# Introduction

## Purpose of this Report

This Response to Submissions Design Report has been prepared by Foster+Partners on behalf of the Pitt Street Developer North Pty Ltd to address the matters raised by government agencies, the public and community organisation groups during public exhibition of the proposed Sydney Metro Pitt Street North Over Station Development (OSD) State Significant Development (**SSD**).

New 201 Elizabeth Street Stage 1 DA Envelope

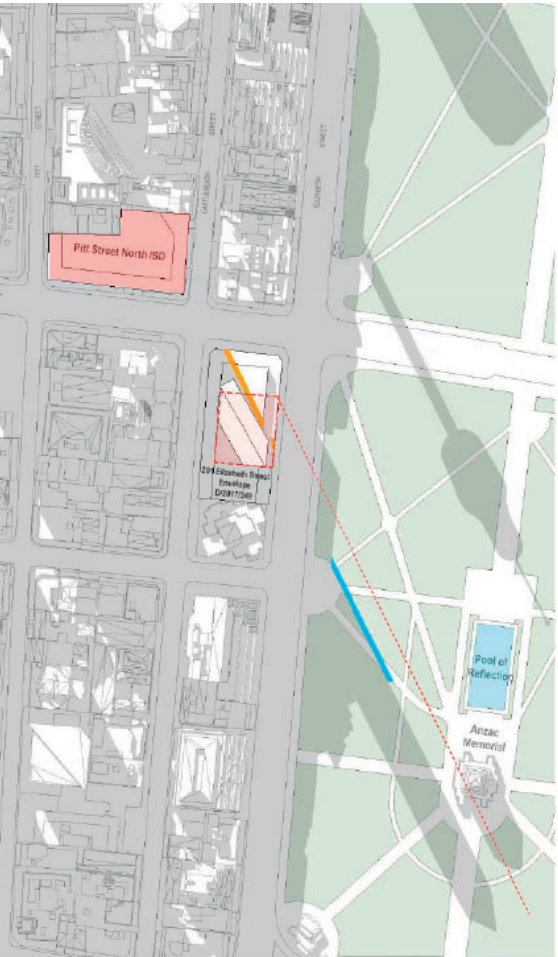
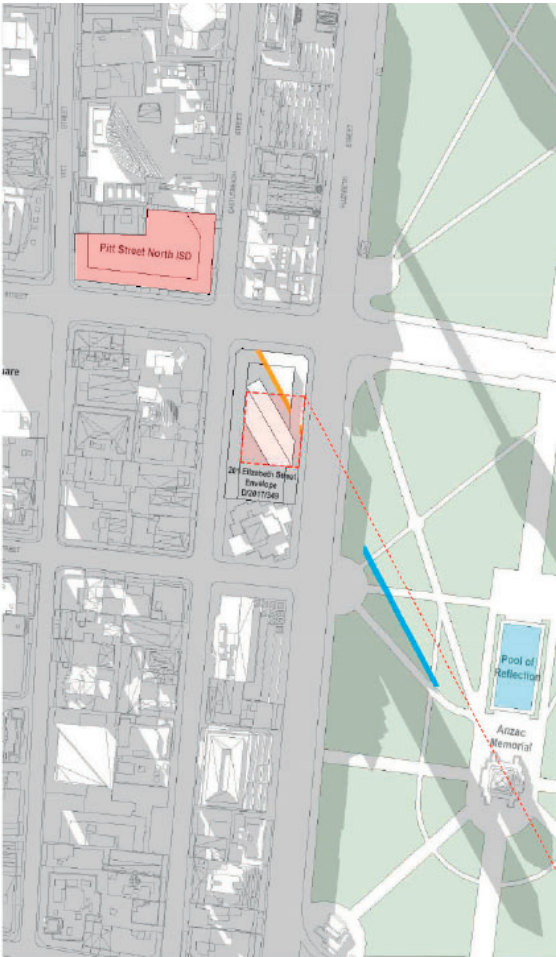
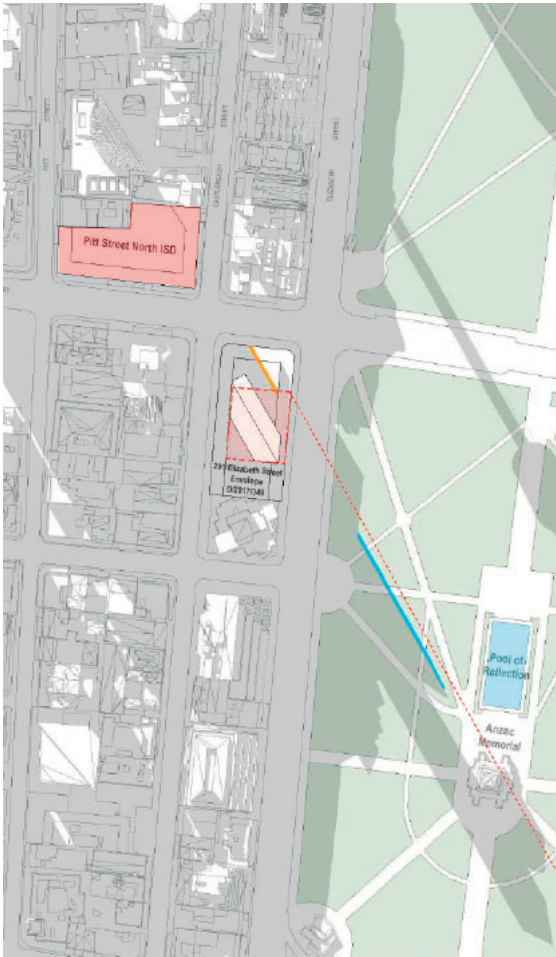
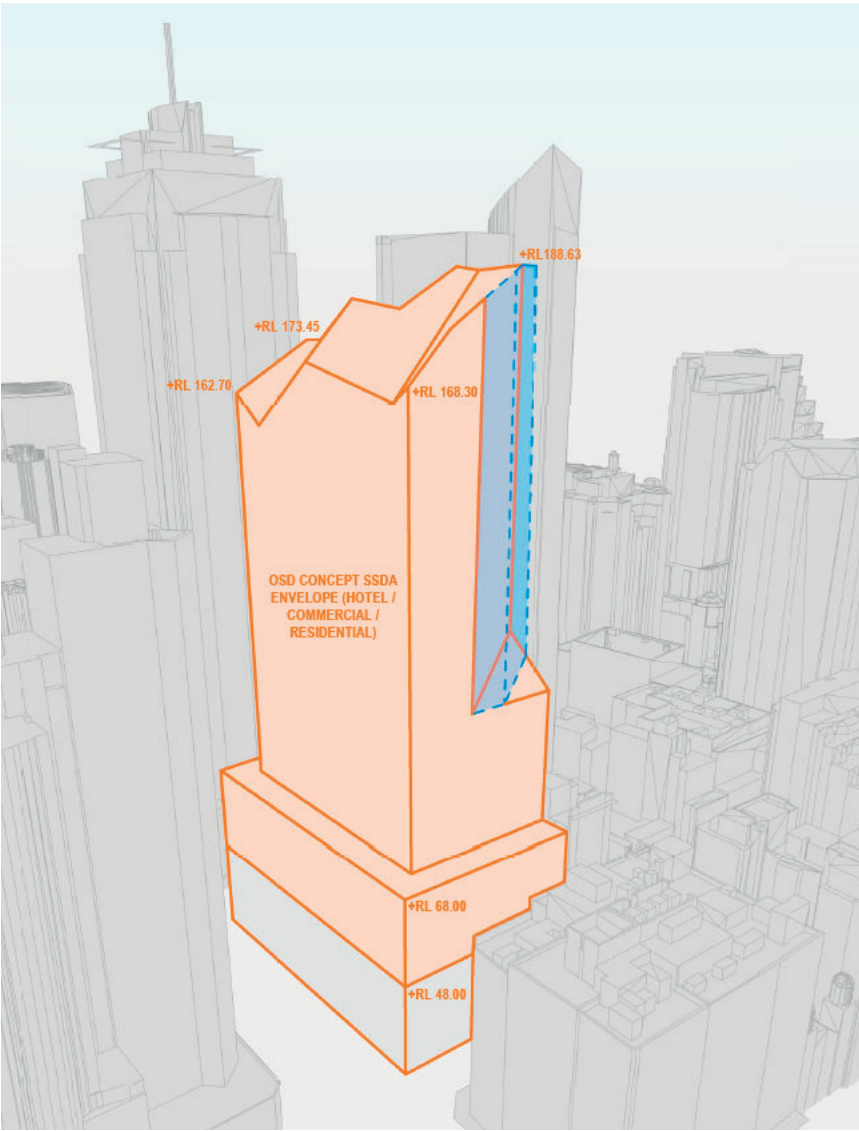
Review the distribution of floor space to minimise external impacts and satisfy the following Design Guidelines requirements:  
(6.b) Maximise solar access to the public domain, through responding to the reduced shadow cast by the redevelopment of 201 Elizabeth Street on Hyde Park on June 21st, between 12pm and 2pm -Sydney Metro preliminary design work propose an angled offset of the north eastern corner of 4.1m to achieve this outcome.

This study resulted in an additional shadow cast by the Pitt Street North original envelope on Hyde Park on June 21, between the hours of 1.30PM and 2PM, when compared to the reduced shadow cast by the newly approved 201 Elizabeth Street Stage 1 massing (refer to diagrams below).

3D Perspective View Stage 1 Envelope

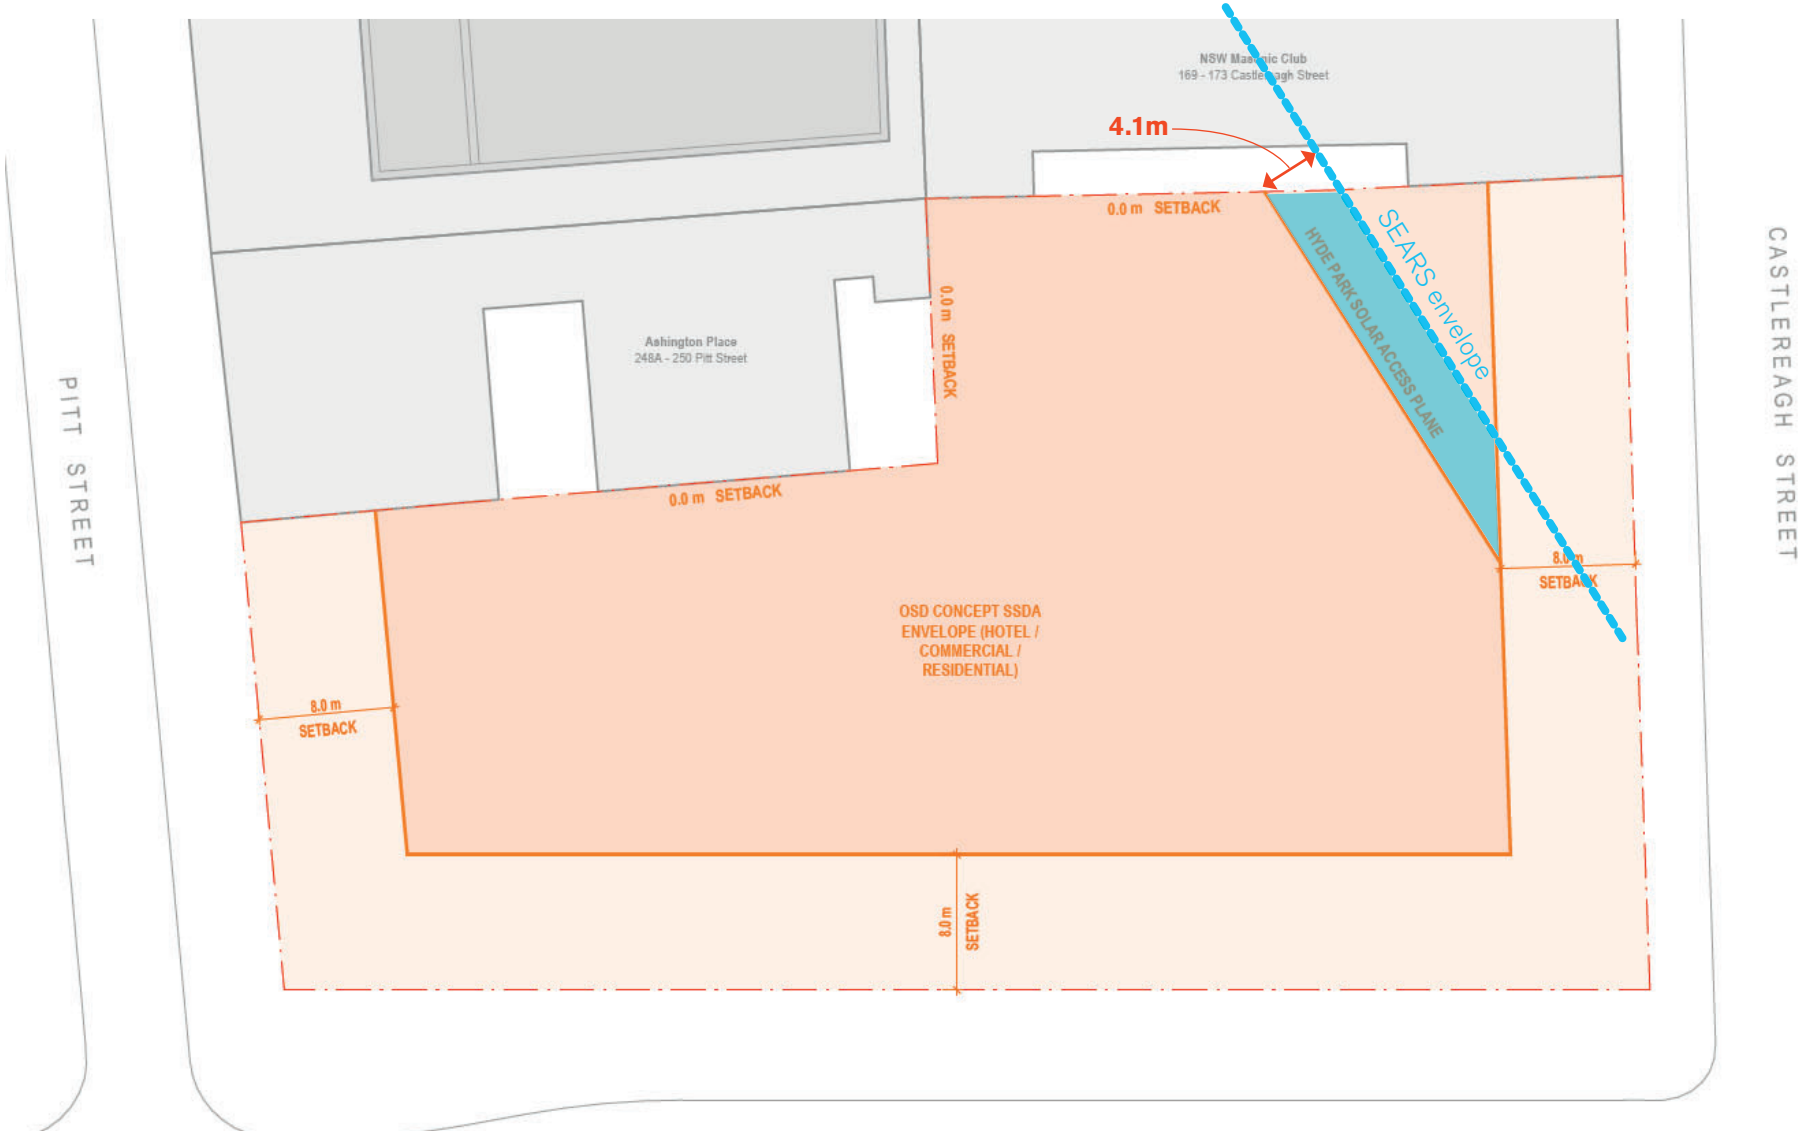
Review the distribution of floor space to minimise external impacts and satisfy the following Design Guidelines requirements:  
(6.b) Maximise solar access to the public domain, through responding to the reduced shadow cast by the redevelopment of 201 Elizabeth Street on Hyde Park on June 21st, between 12pm and 2pm -Sydney Metro preliminary design work propose an angled offset of the north eastern corner of 4.1m to achieve this outcome.

The result impacted the north-eastern corner of the Pitt Street North Envelope, requiring the angled corner to the North-East to be offset 4.1m, removing 87 sqm from the typical tower level envelope.

Section through typical North-East Tower Elevation

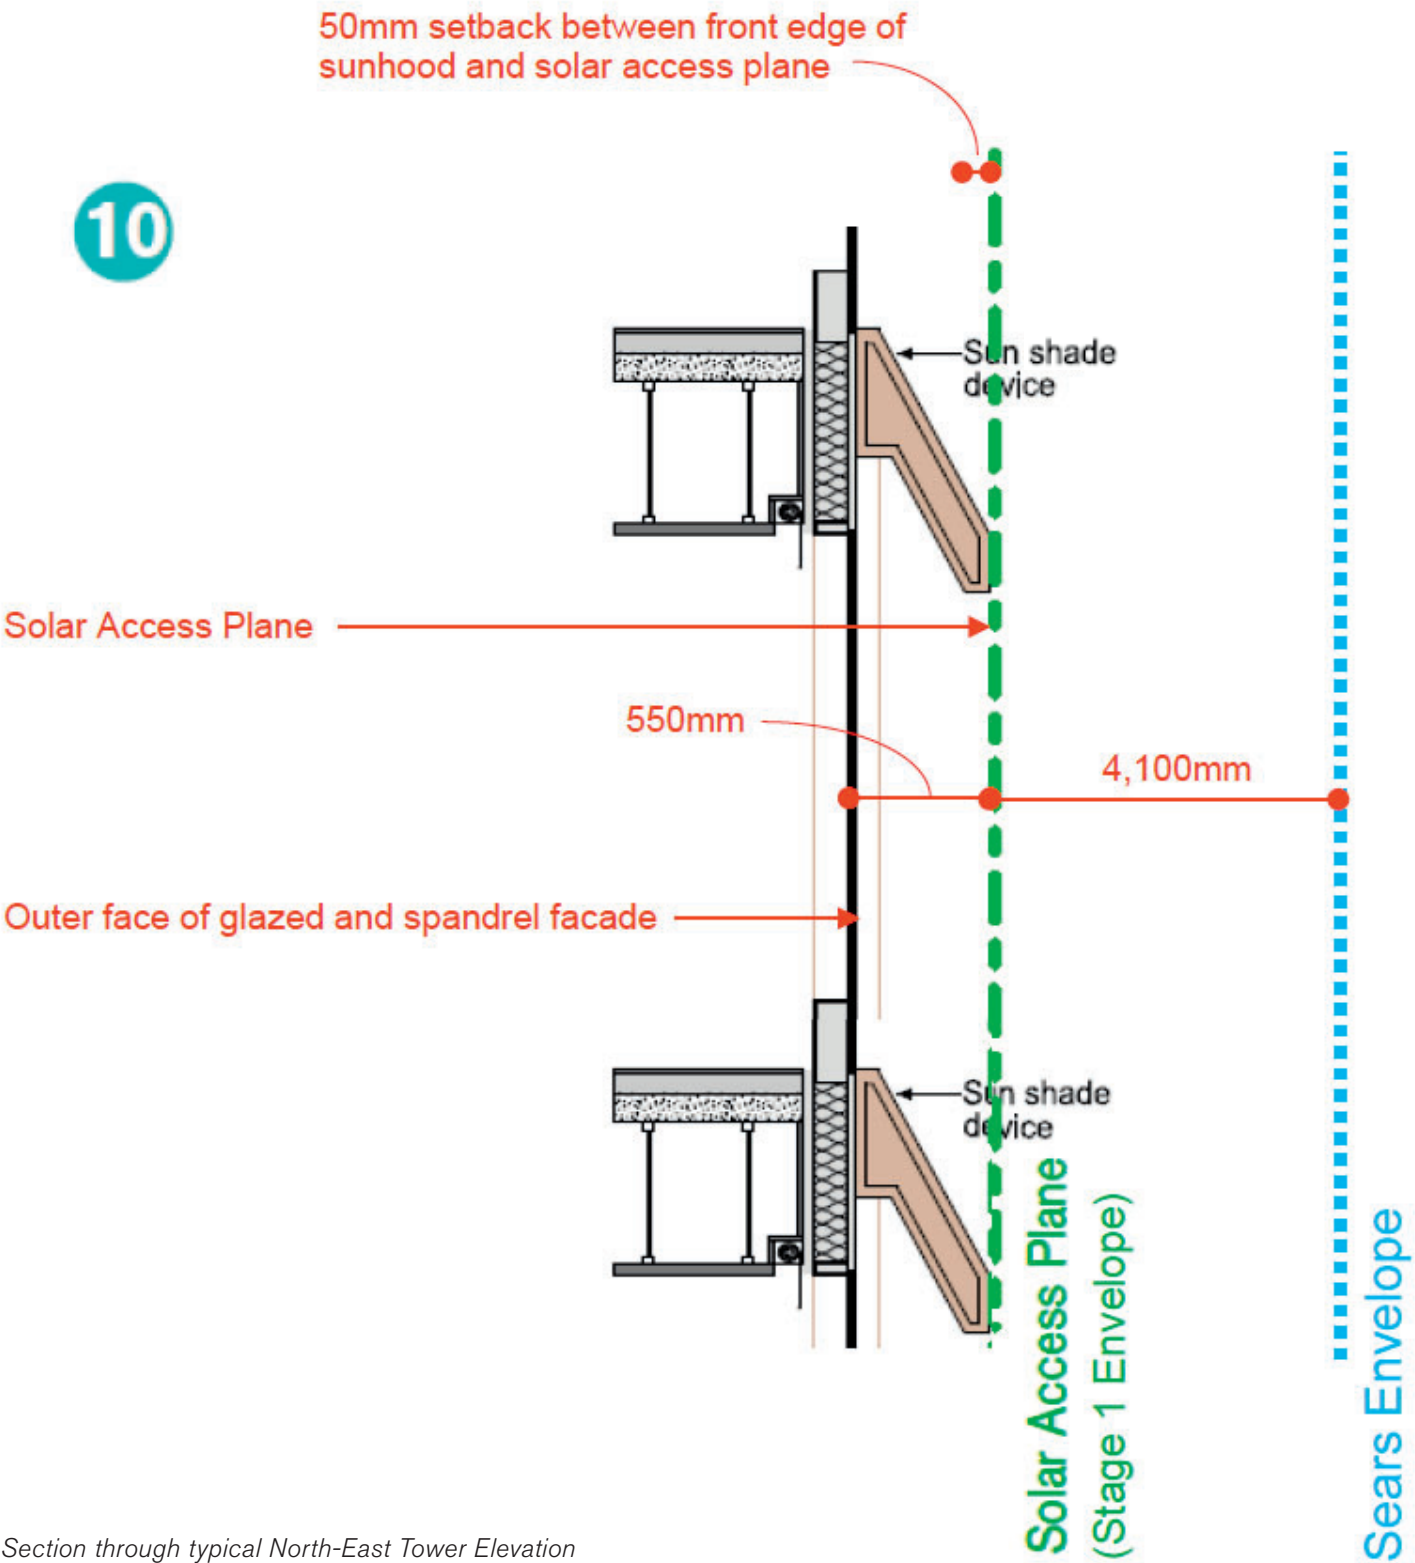
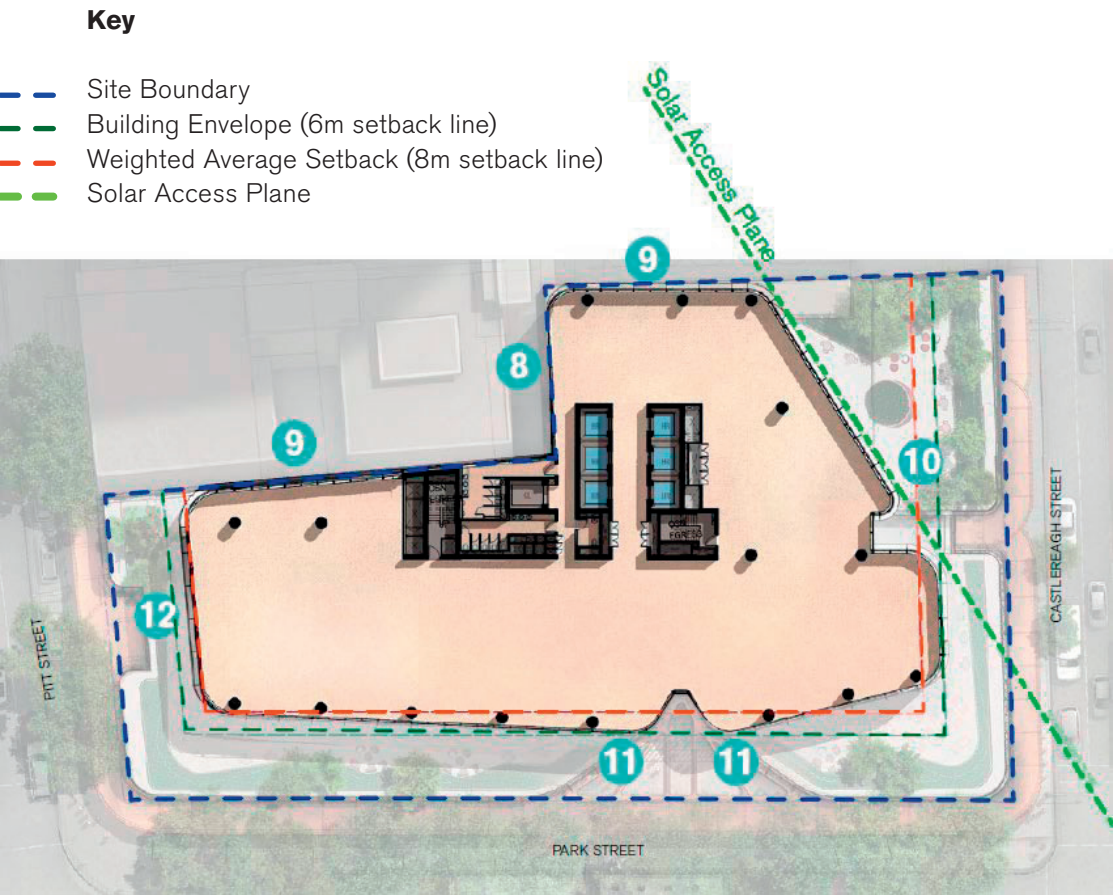
Review the distribution of floor space to minimise external impacts and satisfy the following Design Guidelines requirements:  
(6.b) Maximise solar access to the public domain, through responding to the reduced shadow cast by the redevelopment of 201 Elizabeth Street on Hyde Park on June 21st, between 12pm and 2pm -Sydney Metro preliminary design work propose an angled offset of the north eastern corner of 4.1m to achieve this outcome.

With the Solar Access Plane established as an offset of 4.1m from the original SEARs envelope, the facade outline to this North-Eastern corner of the development has been further set back an additional 550mm from the Solar Access Plane.  
The front edge of the expressed horizontal sunhoods is set off 50mm from this same Solar Access Plane as indicated on the sectional diagram on this page.  
The following pages show compliance with the requirement of no additional overshadowing to Hyde Park on June 21st between the hours of 12pm to 2pm when shown in light of the approved Concept Envelope on 201 Elizabeth Street.
